TECH-NIQUE

S-248

SUBJECT: COPSCAN MONITOR

COMPONENT LAYOUT

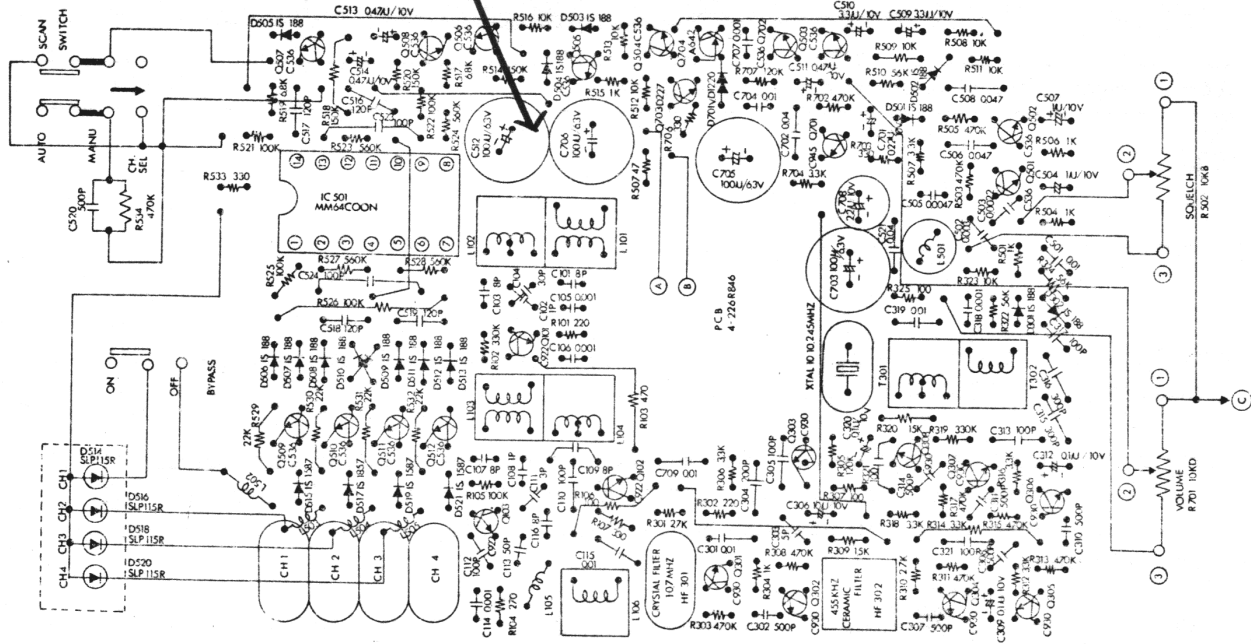
In case the "Carrier Delay" feature is desired to be eliminated, remove capacitor C-512 (100 mfd. @ 6.3V).

By removing this component, the 2 second time delay (after carrier is off) will be eliminated. This modification is primarily intended for receiving transmissions when two stations are communicating on two separate transmit frequencies.

The part may be removed without removing the P. C. Board by carefully twisting (back and forth) the capacitor body, and fatiguing the capacitor's wire leads.
